NIAGARA MOHAWK POWER CORPORATION

LICENSE NO. DPR-63

Proposed Changes to Technical Specifications (Appendix A)

Supporting Information and No Significant Hazards Consideration Analysis

NMP-1 HIGH PRESSURE FEEDWATER SYSTEM SCHEMATIC

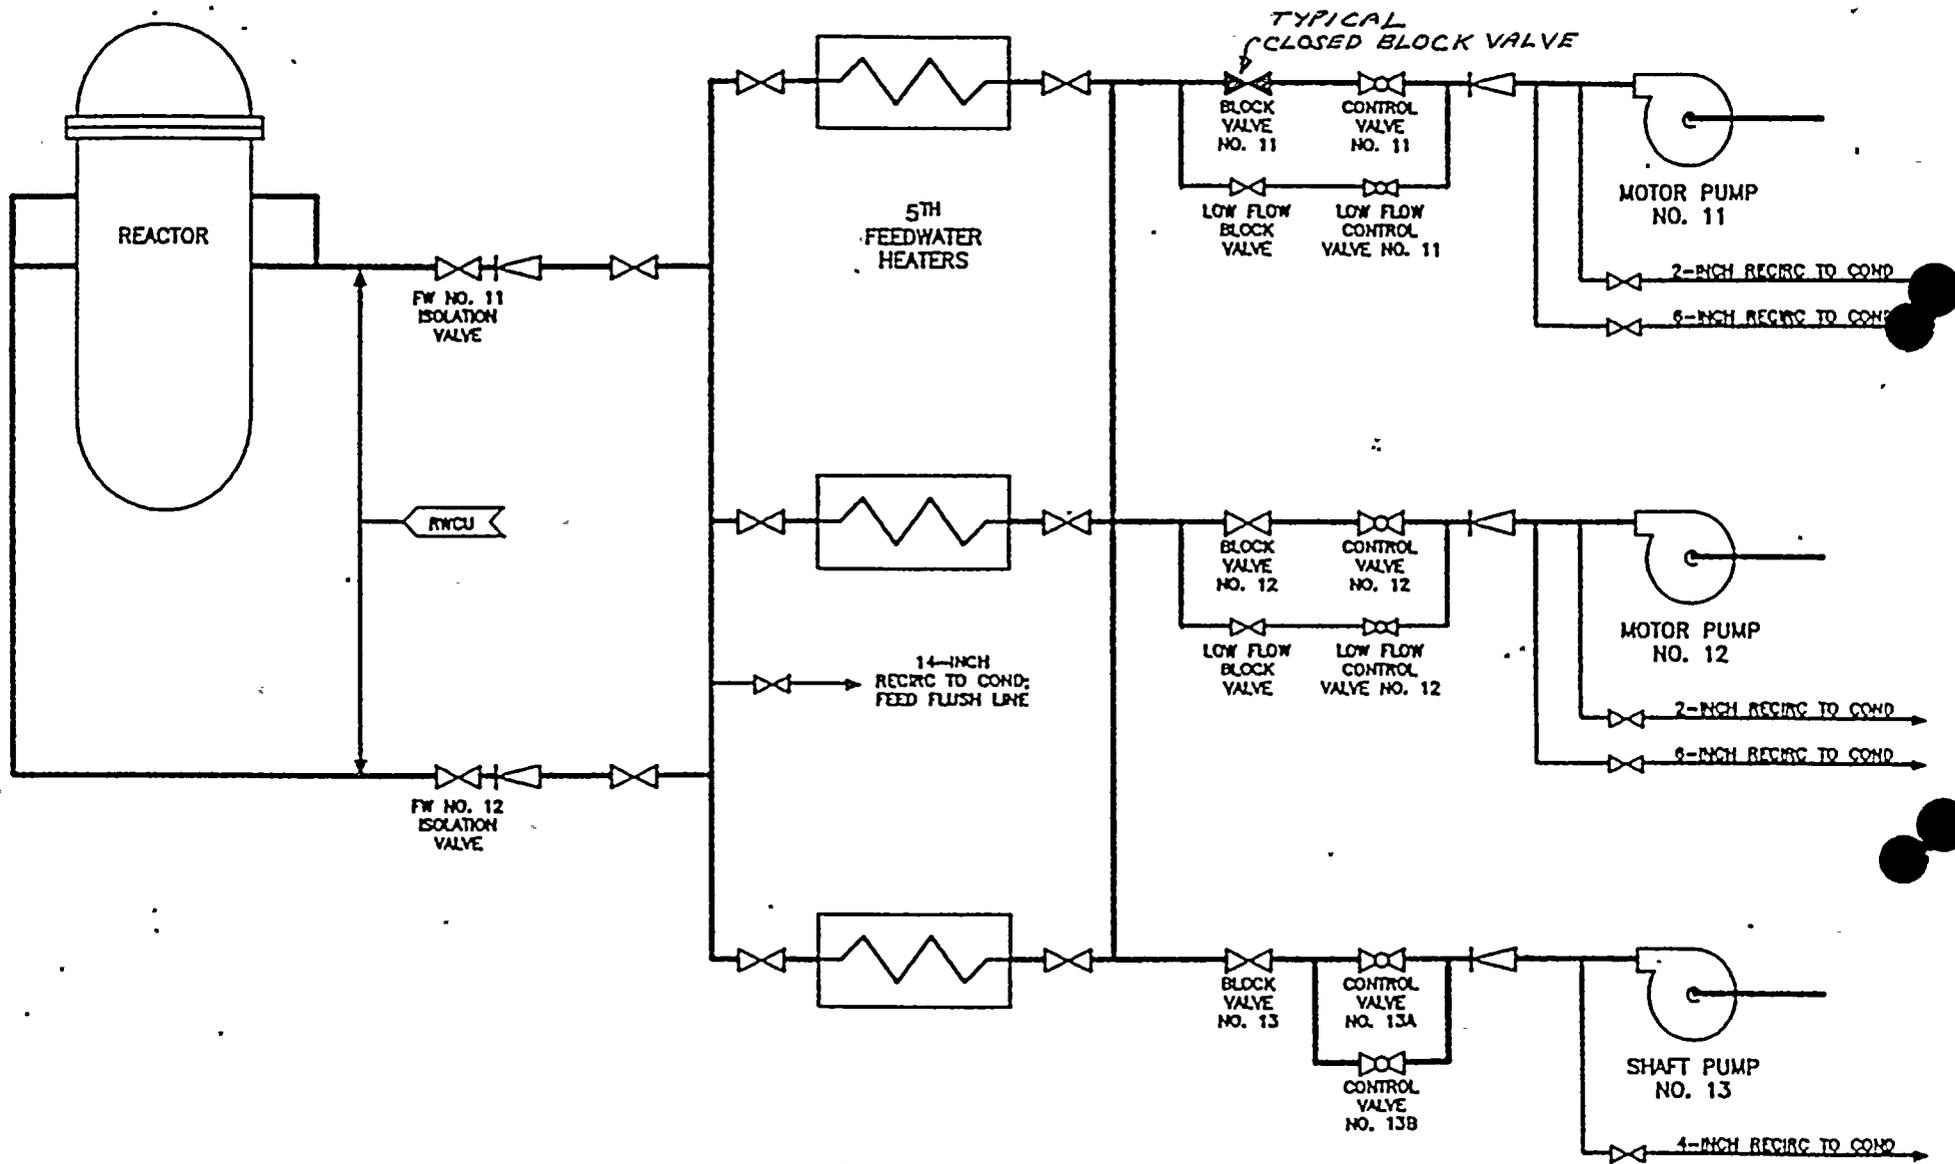
The proposed change will allow plant startup with the operating motor driven feedwater pump blocking valve in the closed position. This blocking valve is motor operated. The blocking valve on the idle train would be open. In this evaluation, the term main flow control valve refers to Flow Control Valves 11 or 12 controlling flow of their respective electric motor driven feedwater pumps. The minimum flow control valve is a bypass valve around the main flow control valve and is intended to control feedwater flow during periods of low feedwater demand. Figure 1 shows a piping schematic.

It is estimated that the low flow control valve will pass approximately 1250 gpm of feedwater at reactor operating pressure. At lower reactor pressure, the amount would be larger (2000 gpm below 350 psi). At steady state conditions, this would be approximately 9% of rated feedwater flow ( $7.29 \times 10^6$  lbm/hr) so that the blocking valve would be opened shortly after the operator places the reactor mode switch in RUN during the plant startup.

When the reactor is in the process of startup, the LOCA makeup requirements are reduced because of lower pressures, decay heat, and reactor power than those assumed in Appendix K, 10 CFR 50 requirements. With the feedwater blocking valve closed, the operating feedwater train would be capable of providing approximately 1250 gpm of feedwater to the reactor up to a reactor pressure of 1050 psig. The idle feedwater train (Preferred HPCI train) with its blocking valve open would remain capable of supplying 3800 gpm of feedwater upon automatic HPCI initiation at all reactor pressures. The HPCI initiation signal would activate the idle feedwater train in the HPCI mode. Plant procedure (N1-OP-43, Startup and Shutdown) is being revised to require reactor startup with the non preferred HPCI train (Feedwater Pump 11) in service. Closure of the low flow by-pass valve on the operating train would occur but the reactor operator could manually initiate opening of the closed blocking valve. This valve would be open in approximately 60 seconds after initiation.
